Groundwater Transfer Review Summary Form

Transfer/PA # T- <u>13368</u>
GW Reviewer <u>Aurora C Bouchier</u> Date Review Completed: <u>8/5/2020</u>
Summary of Same Source Review:
☐ The proposed change in point of appropriation is not within the same aquifer as per OAR 690-380-2110(2).
Summary of Injury Review:
☐ The proposed transfer will result in another, existing water right not receiving previously available water to which it is legally entitled or result in significant interference with a surface water source as per 690-380-0100(3).
Summary of GW-SW Transfer Similarity Review:
☐ The proposed SW-GW transfer doesn't meet the definition of "similarly" as per OAR 690-380-2130.
This is only a summary. Documentation is attached and should be read thoroughly to understand the basis for determinations.

Transfer Application: T-13368

Theis drawdown analysis: authorized POA (MARI 4684) to nearest inspected well (MARI 69251)

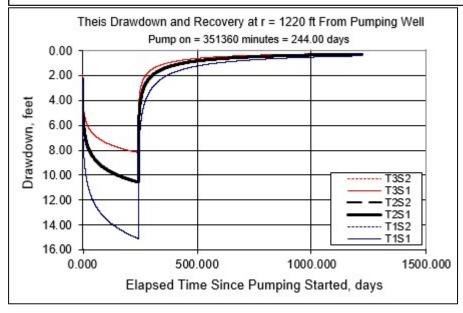
b) If yes, would this proposed change, at its maximum allowed rate of use, likely result in another groundwater right not receiving the water to which it is legally entitled? Yes No If yes, explain: A drawdown estimate made using the Theis distance-
	drawdown indicates that up to approximately 2 feet of additional drawdown may be seen in MARI 69251 due to pumping at 120 gpm (the assumed maximum rate for the 19.0 acres involved) at MARI 68166 under this transfer. It is unlikely that this amount of additional drawdown will prevent this, and other similarly located wells, from receiving water to which they are legally entitled.

Theis drawdown analysis: proposed POA (MARI 68166) to nearest inspected well (MARI 69251)

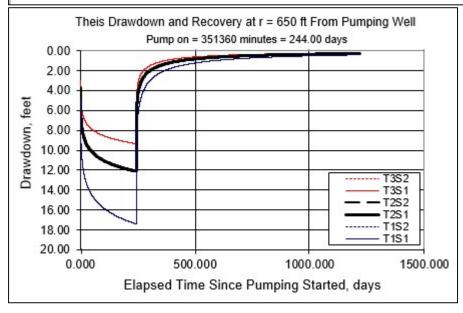
4.	a) Will this proposed change, at its maximum allowed rate of use, likely result in an increase in interference with another ground water right ?
	Yes No Comments: Claim GR 334 also uses MARI 68166 for primary irrigation of 20 acres with an authorized maximum rate of 1.114 cfs (approximately 500 gpm). It is not certain that MARI 68166 would be capable of producing at a combined maximum rate to cover both Claim GR 334 and the 19.0 acres under this transfer application from Claim GR 305. Of note, the place of use for both Claim GR 334 and the POU for this transfer have the same owner.
	Relative to the authorized POA, the proposed POA is approximately 570 feet closer to an inspected well (MARI 69251), located on the north of Hazelgreen Road NE. The increase in proximity will likely result in an increase in interference with MARI 69251.
